# **DART SERVICE INSTRUCTION**

**TO AMEND INSTALLATION INSTRUCTIONS IIN-D212-664 REV. J OR LATER APPROVED REVISION  
& INSTRUCTIONS FOR CONTINUED AIRWORTHINESS ICA-D212-664 REV.11 OR LATER APPROVED REVISION**

A	NEW ISSUE	SAD	21.10.14
REV.	DESCRIPTION	BY	DATE
DESIGN	SAD	<b>DART AEROSPACE LTD</b> HAWKESBURY, ONTARIO, CANADA	
DRAWN	SAD		
CHECKED	RF	DRAWING NO.	REV. A
MFG. APPR.	N/A	DSI 9866	SHEET 1 OF 2
APPROVED	CP	TITLE	SCALE
DE APPR.	CP 	BEAM ASSEMBLY INTERFERENCE	NTS
DATE	21.10.14	COPYRIGHT © 2021 BY DART AEROSPACE LTD. <small>THIS DOCUMENT IS PRIVATE AND CONFIDENTIAL AND IS SUPPLIED ON THE EXPRESS CONDITION THAT IT IS NOT TO BE USED FOR ANY PURPOSE OR COPIED OR COMMUNICATED TO ANY OTHER PERSON WITHOUT WRITTEN PERMISSION FROM DART AEROSPACE LTD.</small>

**FIGURE 1: D5380-1/-3 SUPPORT**  
**D412-664-403 AFT CROSSTUBE (HIGH GEAR, HEAVY-DUTY)**  
 (CROSSTUBE PARTIALLY SHOWN)

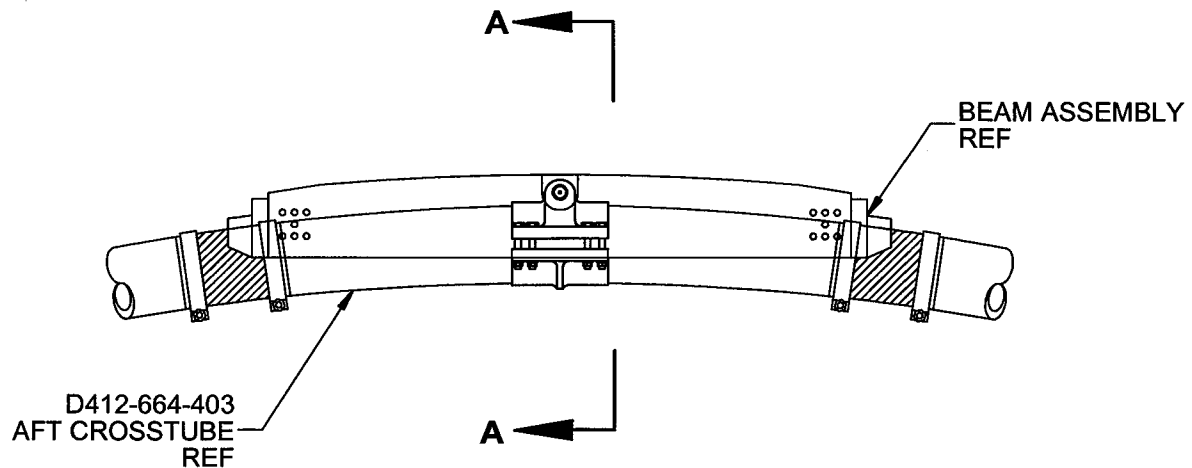
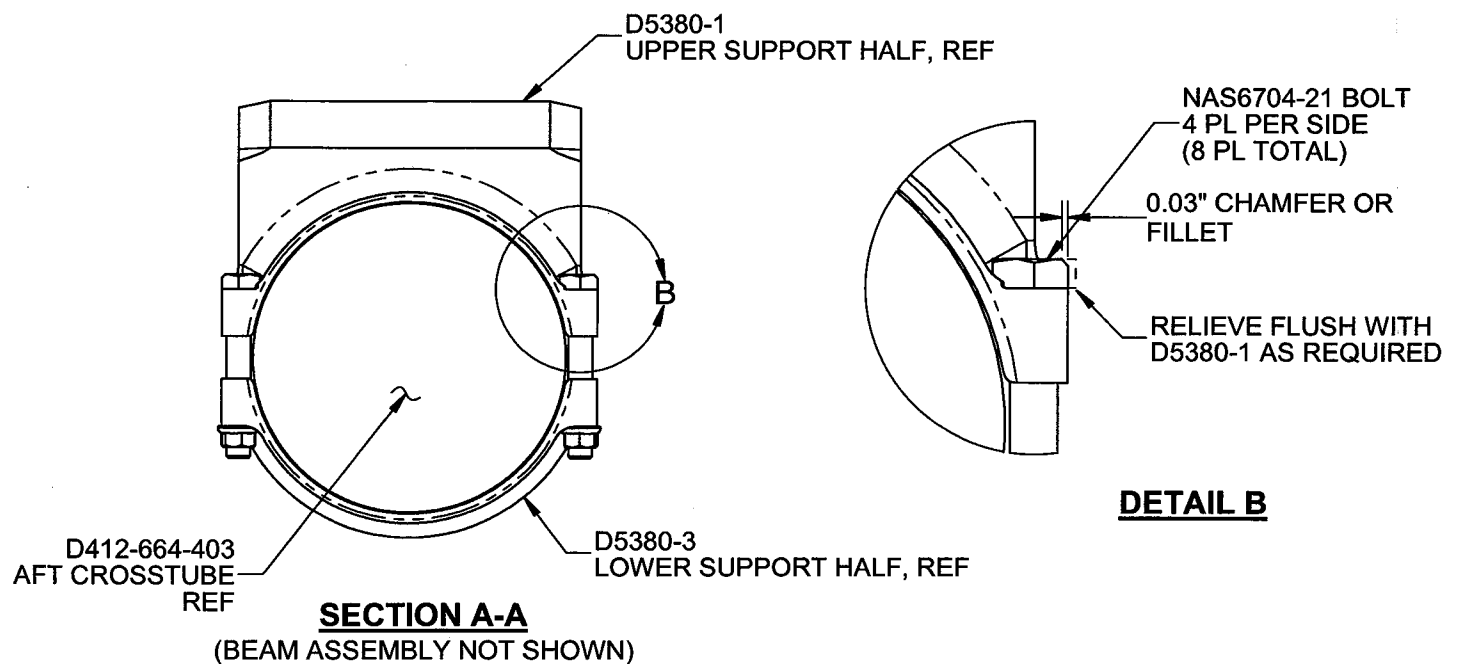
For the D412-664-403 Aft Crosstube, customers have reported contact between the center support and 604-030-001 Beam Assembly (ref). The contact is evidenced by abrasion from the center support's bolt heads on the interior of the beam assembly. The purpose of this Dart Service Instruction (DSI) is to permit customers to relieve the bolt heads to prevent contact.

Reinstall the Beam Assembly and attaching hardware on the D412-664-203/-205/-209/-403. For the D412-664-403 Aft Crosstube, move the Beam Assembly through its full range of possible movement and ensure there is no contact between the NAS6704-21 bolts and the Beam Assembly. If contact is possible, relieve the bolt heads on the affected side(s) as follows:

- i) Remove the Beam Assembly
- ii) Relieve heads of NAS6704-21 bolts to be flush with sides of the D5380-1 Upper Support Half as shown in Figure 1 of this DSI.
- iii) If damage is visible on the Beam Assembly, inspect and touch-up per the Aircraft Maintenance Manual.
- iv) Reinstall the Beam Assembly and attaching hardware.
